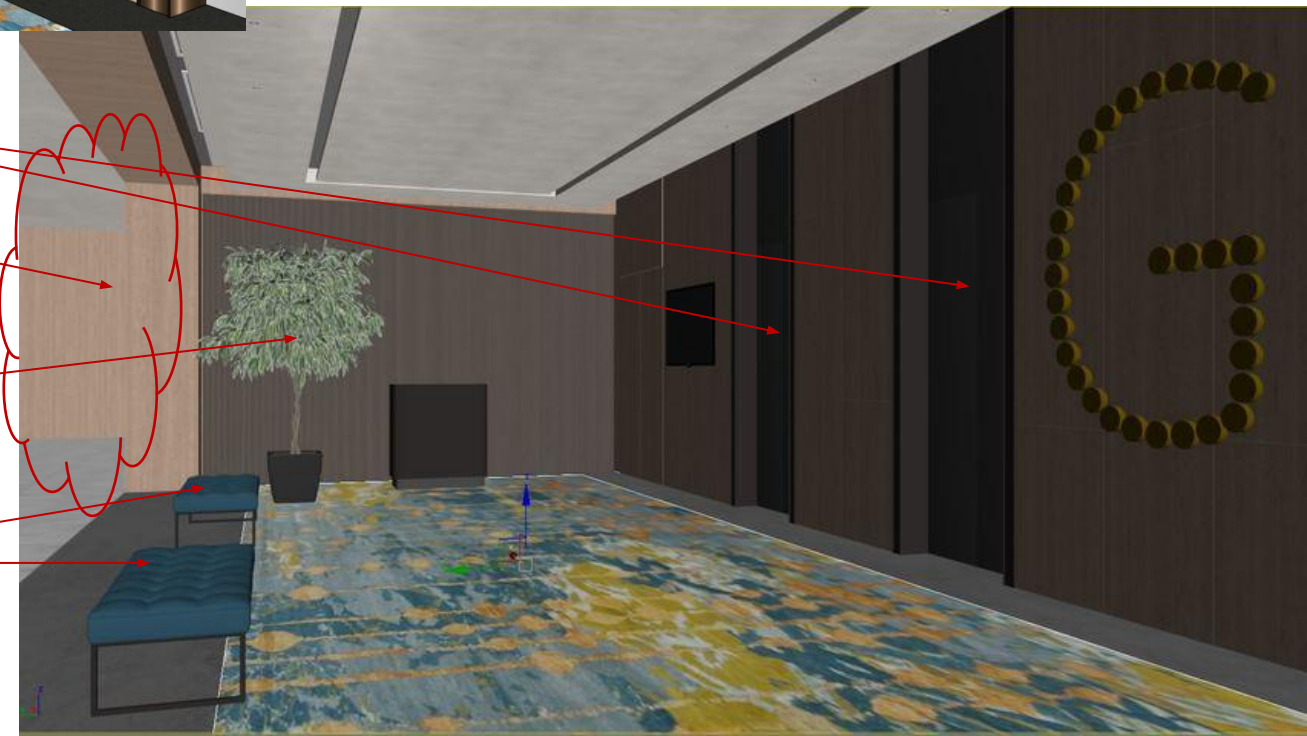
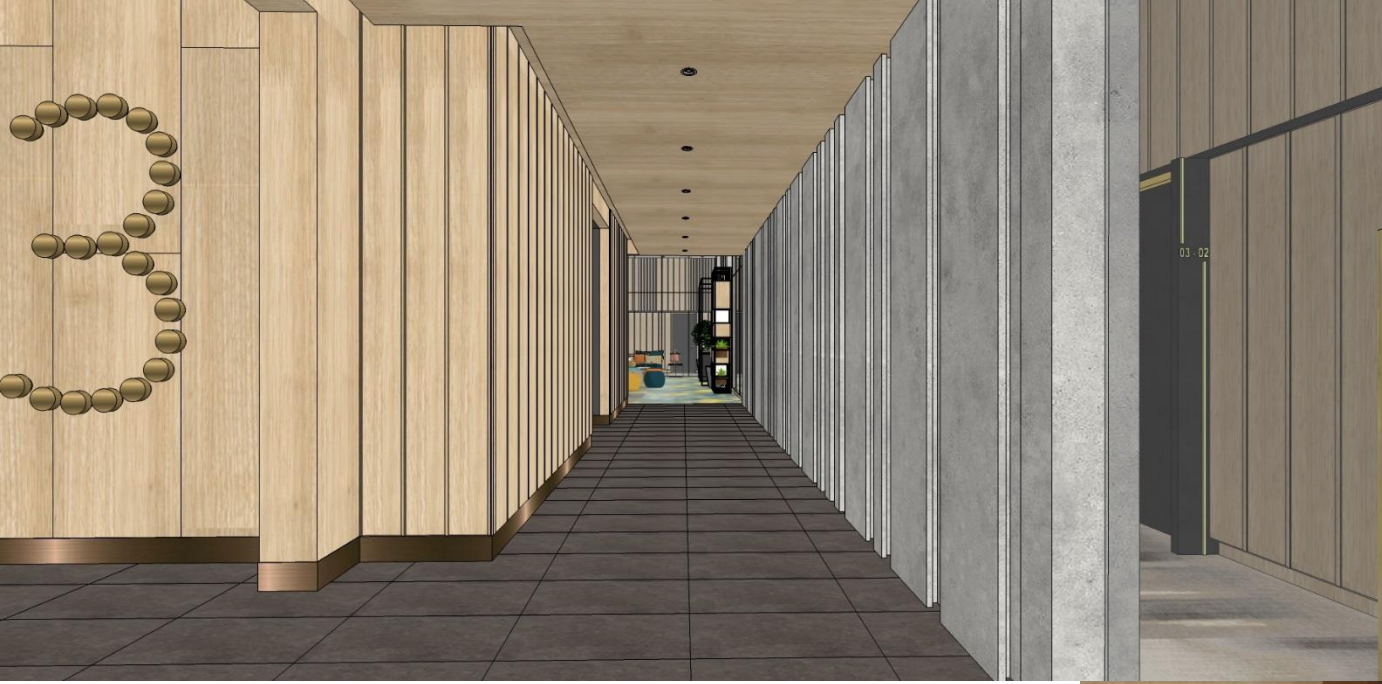
View and angle to follow as per sketch up!
Rendered view needed to comment further.
To have day sun light.

Perimeter Cove light around recess ceiling

lift car frame in s/steel hairline finish

View and angle to follow as per sketch up!
Rendered view needed to comment further.

- Lift car in s/steel hairline finish
- Glass door to add as per sketch up
- Plant to follow as per sketch up
- Furniture arrangement to follow as per sketch up

Too yellowish, less down exterior sunlight!
To show more interior lighting

Light cove at the recess area

Deco panel to extend.
Please refer as per sketch up

Reference light source to archive

lift car frame in
s/steel hairline finish

Arch opening height @ 2400mm &
Grove line required as per sketch up

Recess area with indirect light

Lighting temperature to make sure is
consistent with others area.
Less down exterior sunlight.

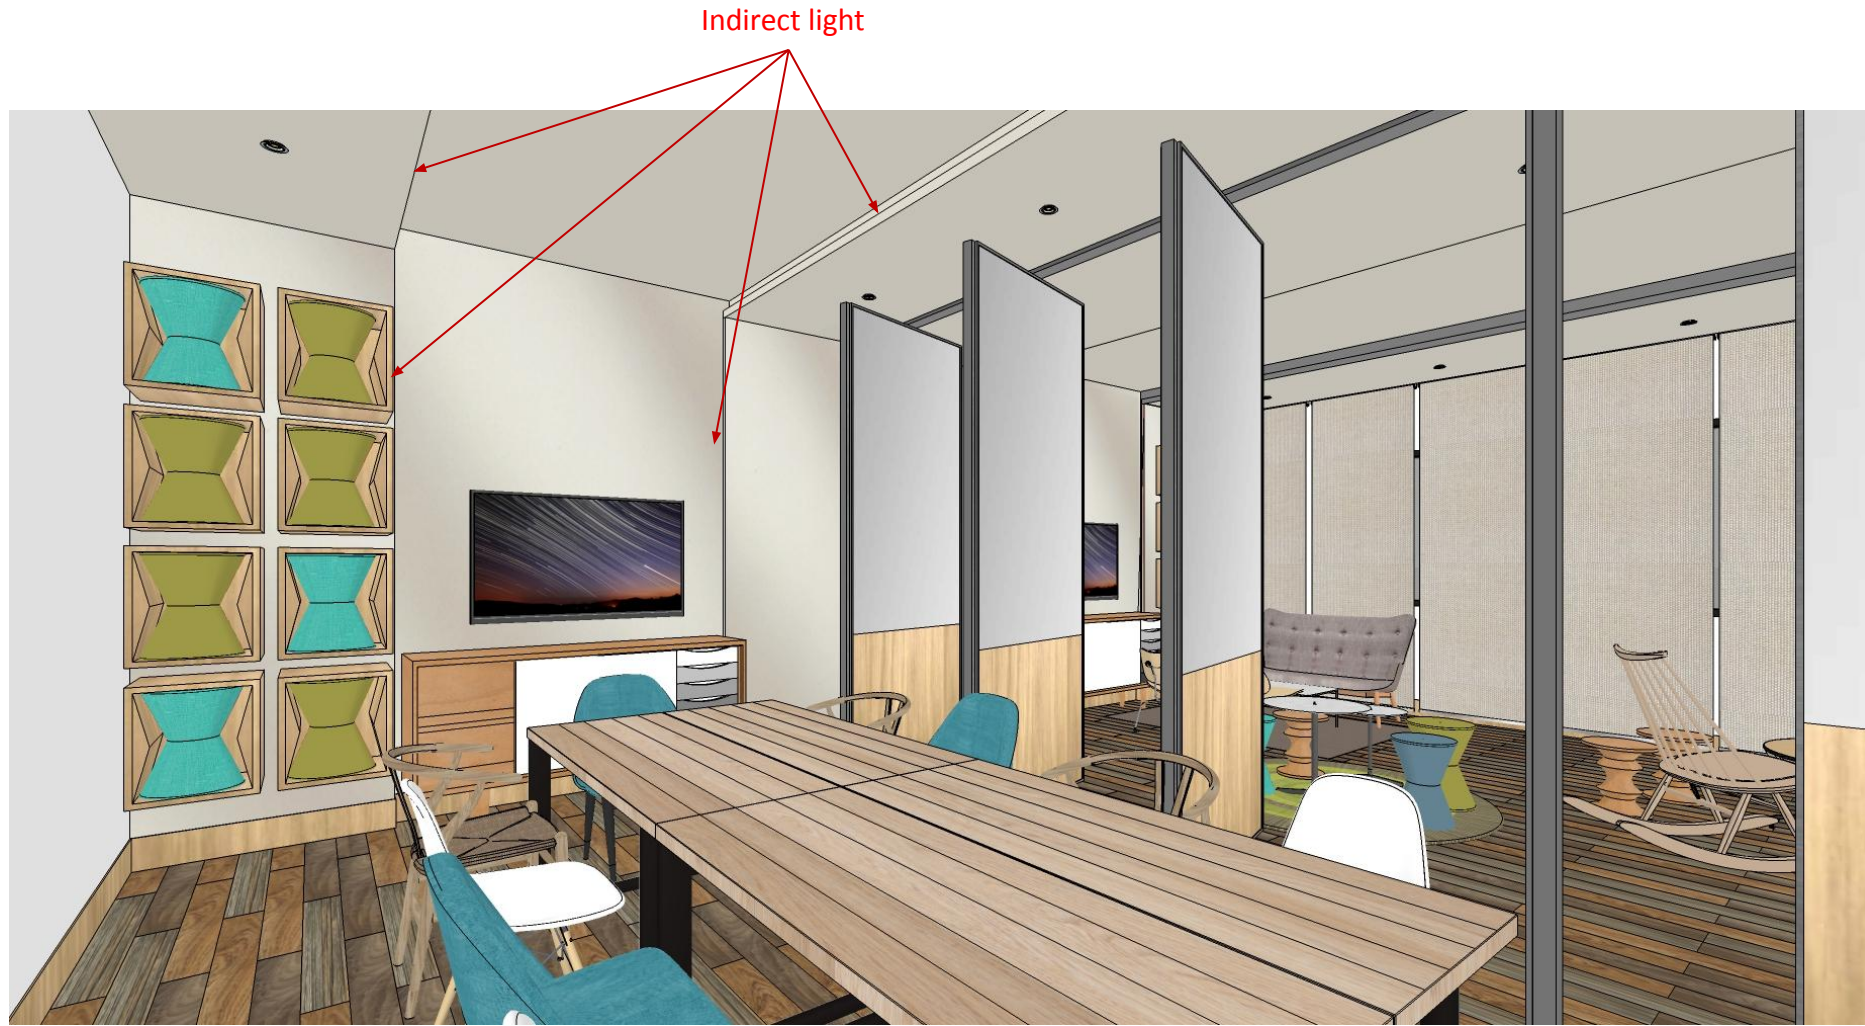
Door frame too thick.
30mm will do.

Deco follow to follow
type A1 bath

Tv to turn on
as per sketch up

Moveable panel top part in
colour glass finish.

Light up the next room

10mm Groove line required
between colour glass and laminate
